Access Compliance Report Public Rights-of-Way (Curb Ramps)

Main Street: PACIFIC_AVE Cross Street: MAGNOLIA_AVE Location: SE

ADA ID: RPAT211129104147 Ramp Type: Type 4 - Parallel Initial Pass/Fail: Fail Overall Compliance: No Severity Score: 30

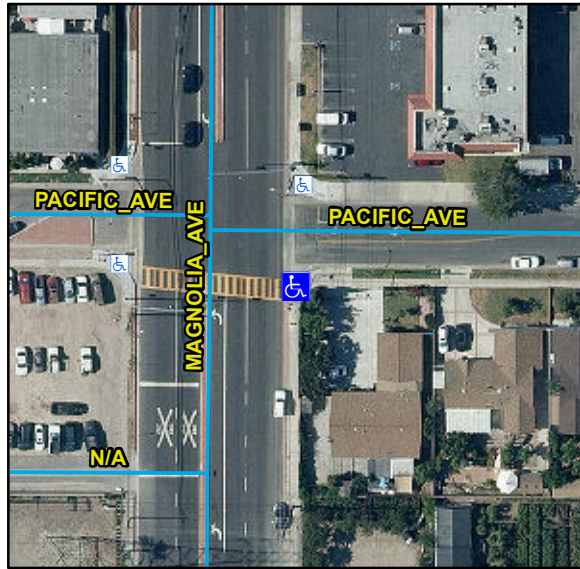
Compliance	Description	Data	Compliance	Description	Data
N/A	Ramp Length LT (in)	73	N/A	Ramp Length RT (in)	99
Yes	Ramp Width LT (in)	76	Yes	Ramp Width RT (in)	91
Yes	Ramp Run Slope LT (%)	2.3	Yes	Ramp Run Slope RT (%)	7.2
No	Ramp Cross Slope LT (%)	7.7	Yes	Ramp Cross Slope RT (%)	0.7
N/A	Landing Present	N/A	N/A	DWS Provided	N/A
N/A	Landing Length (in)	N/A	N/A	DWS Contrast	N/A
N/A	Landing Width (in)	N/A	N/A	DWS Length (in)	N/A
N/A	Landing Run Slope (%)	N/A	N/A	DWS Full Width	N/A
N/A	Landing Cross Slope (%)	N/A		DWS Offset Type	N/A
N/A	Landing Movement Obstructed?	N/A	N/A	DWS Offset Left (in)	N/A
	Landing Movement Type	N/A	N/A	DWS Offset Right (in)	N/A
N/A	Landing Shared	N/A			
N/A	Clear Space	Yes			
N/A	Clear Space To Crosswalk (in)	N/A			
N/A	Marked Crosswalk 1	No	N/A	Marked Crosswalk 2	Yes
	Crossing 1 Direction	N		Crossing 2 Direction	W
	Marked Crosswalk 1 Width (in)	N/A		Marked Crosswalk 2 Width (in)	120

N/A	Ramp Inside Crosswalk 1	N/A	N/A	Ramp Inside Crosswalk 2	Yes
	Crossing 1 Slope (%)	2.9		Crossing 2 Slope (%)	1.2
	Crossing 1 Cross Slope (%)	0.4		Crossing 2 Cross Slope (%)	1.6
N/A	Gutter Ponding	N/A	No	Curb Slope	10.5
Yes	Gutter Lip Height (in)	0		Road Run Slope (%)	1.9
N/A	Gutter Run Slope (%)	N/A		Road Cross Slope (%)	0.5
N/A	Gutter Cross Slope (%)	N/A	Yes	Perpendicular Joint Present	Yes
Yes	Overall Surface Condition	Acceptable			
	Cross Gutter Present?	Yes		Spandrel Present?	Yes
	Replace Cross Gutter?	No		Replace Spandrel?	No

Remove & Replace Curb Ramp With Two New Directional Ramps or Equivalent.

R304.2.2, R304.5.3, STD 1115
